DEVELOPMENT APPLICATION

Primary Property Lot & DP	28 - 32 Dumaresq Street GORDON NSW 2072 Lot 1 DP961448, Lot 1 DP 103163 & Part Lot 1 DP 949218
Additional Property(/ies) Lot(s) & DP (s) Proposal	No related land Demolish existing improvements and construct a residential flat building containing 34 apartments, basement carpark and landscaping. This proposal also includes a Draft Voluntary Planning Agreement and explanatory note.
Development application no. Ward	DA0501/12 GORDON
Applicant Owner	Australia Wenzhou Group Property Pty Ltd Australia Wenzhou Group Property Pty Ltd & Ku ring gai Council
Date lodged Issues	29/11/2012 Provision of adequate deep soil landscaping to satisfy KPSO provisions; Removal of external loading/turning area to improve landscape amenity; Insufficient on site car parking to satisfy KPSO provisions.
Submissions Land & Environment Court Recommendation Assessment Officer	Yes N/A Approval Anne Moore Consultant Planner

The purpose of this report is to determine DA0501/12. The matter is reported to the JRPP for determination as the development proposed is for a residential flat building with a capital investment value of more than \$5 million (i.e. \$13,601,07

Figure 4 – Lower ground floor level

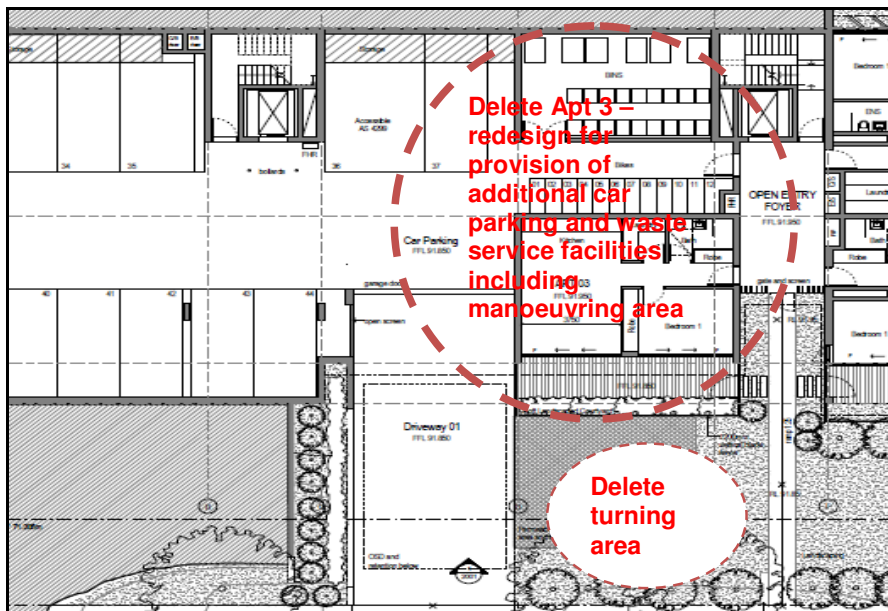
- Whilst parking has been provided within two basement levels, these basement levels extend past the building footprint above and therefore reduce the area available for deep soil landscaping particularly along Dumaresq Street;
- Unless modifications are undertaken to this development proposal as suggested within this report the proposal would not satisfy the objectives of KPSO in that the desired landscape character of the site and municipality will not be achieved; and
- This development proposal could readily be modified with the reduction of one apartment at lower ground level allowing for the provision of one additional parking space due to the reduction in unit numbers, adequate waste storage facilities with an appropriate internal turning area and eliminating the loading/ turning area adjacent to driveway 1 and providing deep soil landscaping to satisfy KPSO provisions.

The variation to the parking standard within KPSO is not supported in this case for the reasons outlined above. It is recommended in **Condition 19** that Apartment 3 at the lower ground level be deleted which is a one (1) bedroom apartment with relatively poor amenity given its single westerly aspect, its positioning adjacent to driveway 1 and overlooking a turning/loading area. The deletion of this apartment would result in one less parking space being required pursuant to the KPSO. The car parking area at this lower ground level could readily be redesigned to provide one additional parking space, adequate waste storage area and an internal turning area for deliveries and waste collection. Refer to **Figure 4** for further details. Council's engineer supports this recommendation. The external turning/loading area could then be suitably landscaped.

Figure 5 – Western elevation

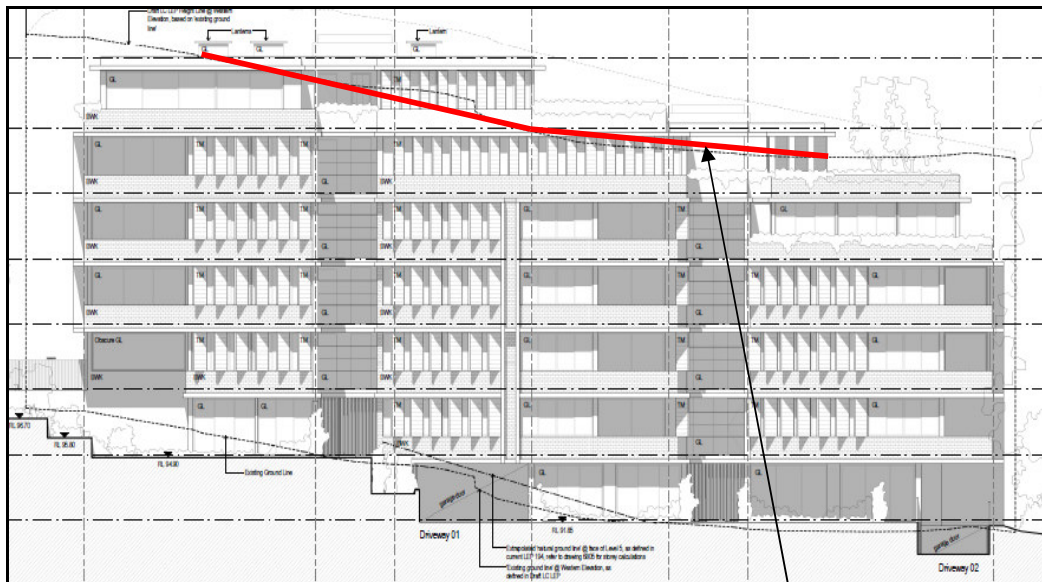
The proposed building has a maximum height of 20.8 metres which exceeds the height limit of KLEP (Local Centres) 2012 by 1.4 metres to 3.3 metres for the middle section of the western elevation of the proposed building as demonstrated by **Figure 5** below. This non compliance is attributed to the topography of the site that slopes from front to rear and which is also affected by an east to west crossfall. The eastern elevation of the proposed building satisfies the height limit. It is emphasised the proposal has been designed to comply with Clause 25 – Rail Corridor and St Ives Centre provisions of the KPSO, which has a complex set of provisions relating to the number of storeys and ceiling heights to control the height of buildings.

Furthermore, the proposed building has been designed to follow the topographic characteristics of the site and the western elevation when viewed from the new road comprises three distinctive vertical elements and is well articulated building with inclusion of numerous openings, balconies, projections, etc. The overall scale and built form is consistent with other residential flat buildings along Dumaresq Street and appropriate for this high density residential locality of Gordon. As the proposal is located at the end of a row of residential flat buildings, it will act as a block end and be a transitional site between high density residential flat buildings to the east and separated by a new road to adjoining low density residential areas to the west. Consequently, the variation to this height control is considered acceptable in this case.
